**Subject:** DRAFT Response to U.S. EPR Design Certification Application RAI No. 546 (6407), FSAR Ch. 6, Questions 06.02.02-129 thru -133  
**Sent Date:** 9/6/2012 5:00:07 PM  
**Received Date:** 9/6/2012 5:01:15 PM  
**From:** WILLIFORD Dennis (AREVA)

**Request for Additional Information No. 546(6407), Revision 0**

**U. S. EPR Standard Design Certification**

**SRP Section: 06.02.02 - Containment Heat Removal Systems**

**Figure D.3-5: Corrosion of Aluminum A1100**

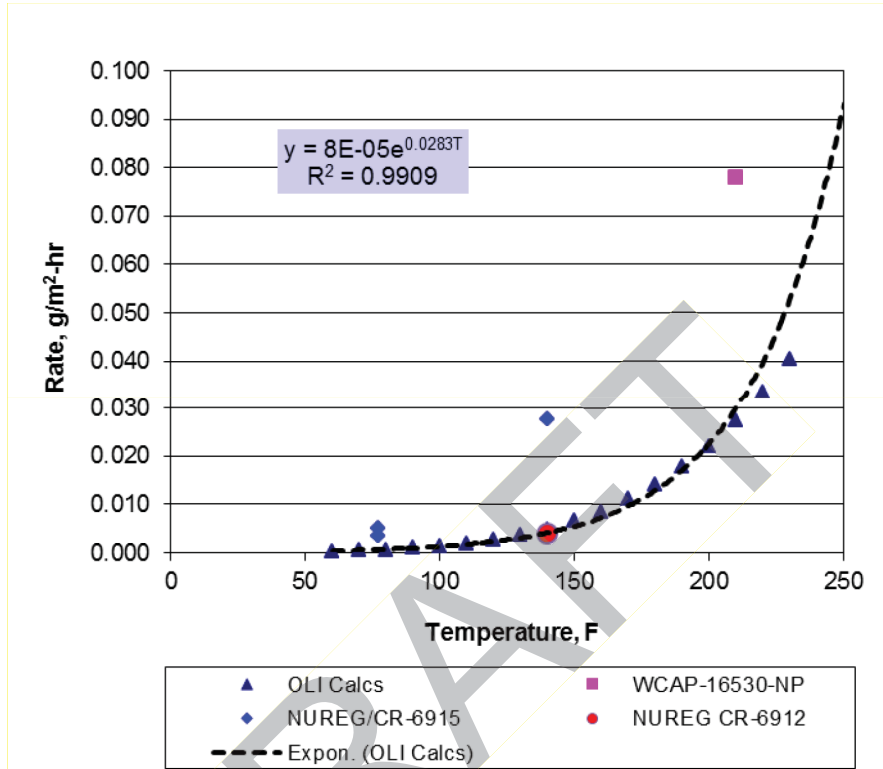
The staff requests that the applicant clarify the source the two data points labeled “WCAP-16530-NP, pH 7” on Figure D.3-5 in ANP-10293P, R4. The corrosion rates for these points, as plotted in the figure, are approximately 0.005 g/m<sup>2</sup>-h at 150°F and 0.078 g/m<sup>2</sup>-h at 220°F. Using WCAP-16530-NP-A, Equation 6-2, the staff calculated release rates of 0.12 g/m<sup>2</sup>-h at 150°F and 1.49 g/m<sup>2</sup>-h at 220°F. The figure shows good agreement between the WCAP data points and the OLI calculations, but the staff was not able to confirm this from the information in the WCAP.

The table below summarizes the discrepancy between the WCAP data points (pink squares) in Figure D.3-5 and the staff’s calculations.

T, °F	<u>Corrosion Rate</u>		<u>Corrosion Rate</u>
	Staff calculation		Figure D.3-5 of ANP-10293P-R4
	mg/m <sup>2</sup> -min*	g/m <sup>2</sup> -hour	g/m <sup>2</sup> -hour (approx.)
150	2.042	0.12	0.005
220	24.87	1.49	0.078

Equation 6.2 of WCAP-16530-NP was not utilized in the calculation of the aluminum release rates because it greatly over-predicts aluminum releases in neutral solution. Rather, the data points from the literature represent experimental data collected for aluminum in neutral solutions.

The first data point (140°F, pH 7) was incorrectly identified as sourced from WCAP-16530-NP. The data point (0.0039 g/m<sup>2</sup>-h or 0.065 mg/m<sup>2</sup>-min) is given in NUREG CR-6912, Table A-4.

The second data point (210°F, pH 7) at 0.078 g/m<sup>2</sup>-h (1.3 mg/m<sup>2</sup>-min) comes from WCAP 16530-NP, Table 6.2-1.

Figure D.3-5 of ANP-10293P should be as follows.
